RIO TINTO
ENERGY AMERICA

Subject: Source Material License No. SUA-1350; Docket Number 04008584
Response to Request for Additional Information (RAI) dated November 19, 2008

RESPONSE TO THE NOVEMBER 19, 2008
REQUEST FOR ADDITIONAL INFORMATION (RAI) REGARDING THE
SWEETWATER MILL CATCHMENT BASIN
EXCAVATION COMPLETION REPORT

Figure 11. Illustration of Ra-226 concentrations excerpted from Catchment Basin Excavation Completion Report.

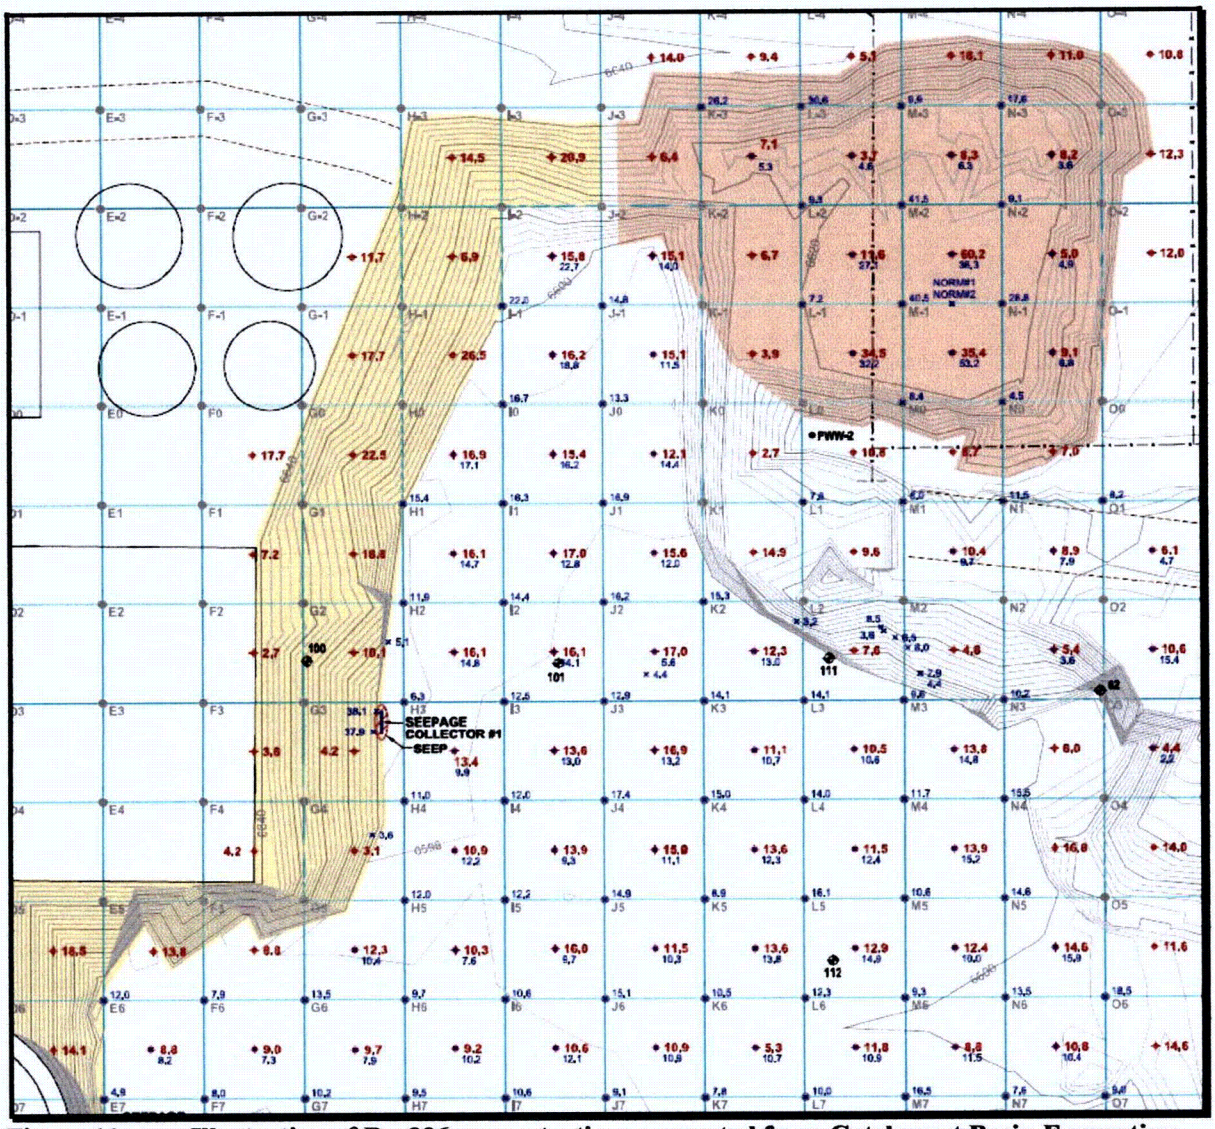
> *In your report, Section IV, Excavation/Grid Release, pg. 5, it states that individual grids and release standards are discussed in the text and these release values for each grid are based upon the nine-point composite sample, as discussed in the pre-excavation submittals. In one of your pre-excavation submittals, dated May 12, 2004, pg. 3, you describe how the cleanup standard for Ra-226 was derived. Please identify the pre-excavation submittal that shows how the natural uranium (35 pCi/g) and Th-230 (15 pCi/g) release standards were derived. If you cannot identify the pre-excavation submittal, please show how these release values were determined.*

Applying the appropriate localized background values given in Table 5 yields the following results: Except for the square area bounded by K-3, K-1, M-3 and M-1, a background value of 10.7 pCi/g would be applied to create a release criterion for Ra-226 of 25.7 pCi/g. This would remove grid blocks D5, G-1, G0, G1 H-1, H0, I-3, and M-4 from further consideration. Additionally grid blocks D5, G-1, G0, G1 H-1, and H0, completely or partially shaded in tan are covered by a synthetic curtain and are excluded on this basis as well. Grid blocks completely or partially shaded in tan are covered by a synthetic curtain and will be addressed at the time the structures are decommissioned as per License condition 9.10 which states in part, " *Residual contamination remaining under structural foundations after the catchment basin remediation shall be removed at the time the structures are decommissioned.*"

The remaining grid blocks in the salmon-colored area that exceed 16.4 pCi/g include L-1, M-2, M-1 and M-4. It is clear that the NORM samples taken in grid M-2 greatly influence the overall concentrations for these three blocks. Applying the proposed background value of 361 pCi/g to the K-3/K-1/M-3/M-1 square would remove all blocks within the square (L-1, M-2 and M-1) from further consideration.

Grid block T5 has a composite average of 36.6 pCi/g Ra-226. An average of the five corner samples for grid block T5 leads to an average of 21 pCi/g and a release criterion of 36 pCi/g. Hence, this grid block should be removed from further consideration.
